**Twelfth Meeting of the Common aeRonautical Virtual
Private Network Operations Group (CRV OG/12)**

Regional IP Network Interconnection Discussion

(Presented by PCCW Global Limited)

Figure 1: Cirion proposed High Level Network Diagram

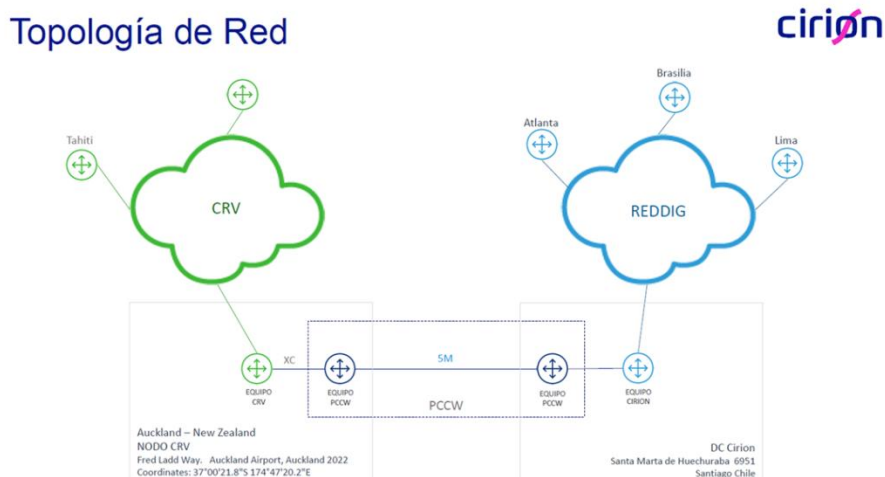
2.3 Explained to Cirion that their design did not work with CRV due to specific requirements from CRV perspective. The proposed high level interconnection diagram (Figure 2) together with questions in technical, commercial and operation were forwarded to Cirion for comment. Please refer to Appendix A for details.

Figure 2: PCCW Global Proposed High Level Interconnection Diagram

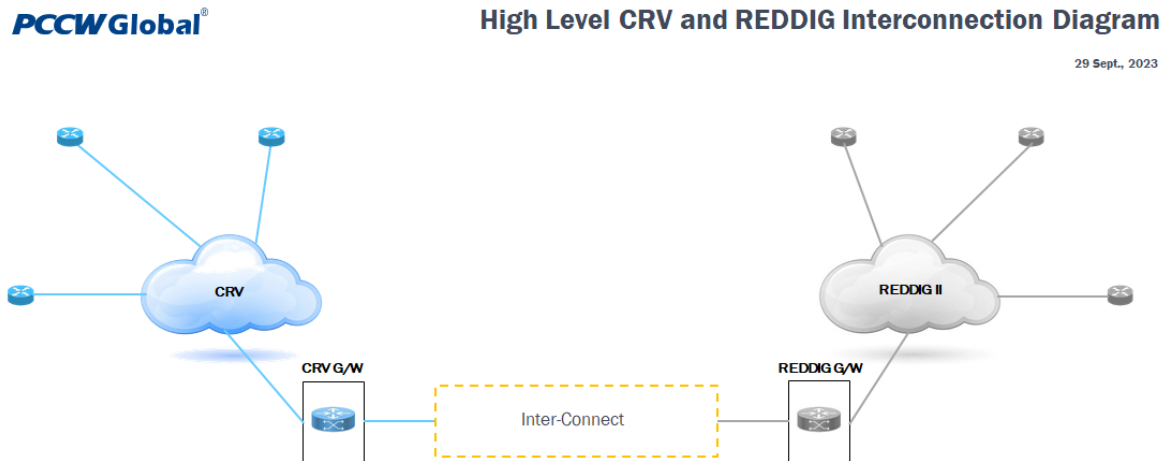
In summary, the solution will include building new CRV interconnection gateway at our end. It is up to your design whether you will build a specific gateway for this connection. The CRV gateway will be near to your gateway/demarcation point so as to minimize interconnect link performance impact. A few more details need to be confirmed before we finalize the solution.

1. The CRV and REDDIG traffic requirements
 - a. CRV to REDDIG: around 3~5 CRV users (total max bandwidth: 10M)
 - b. REDDIG to CRV requirement: [Please confirm?](#)
2. Interconnection Gateway
 - a. CRV will build new specific gateway for the interconnection due to security, governance and CRV technical concerns
 - b. It is upto Cirion if you will build the similar gateway at your end for a clear demarcation for this CRV/REDDIG interconnection service. Please share the location of REDDIG gateway/demarcation for this interconnection service ([Please confirm?](#))
3. Inter-connection Link
 - a. It can be a cross-connect or Layer 2/3 cct (TBD)
 - b. It is a share responsibility (PCCWG and Cirion) for the provisioning, operation and support for this link
4. IP address and CoS

- a. The source and destination IP addresses are compliant to the ICAO Global IP address scheme (10.x.x.x). Only agreed IP/IP subnets are allowed between agreed States via the Interconnection gateway
- b. The CoS is to be defined and agreed – Currently CRV supports Gold, Silver plus, Silver and Bronze. [What CoS does REDDIG support?](#)
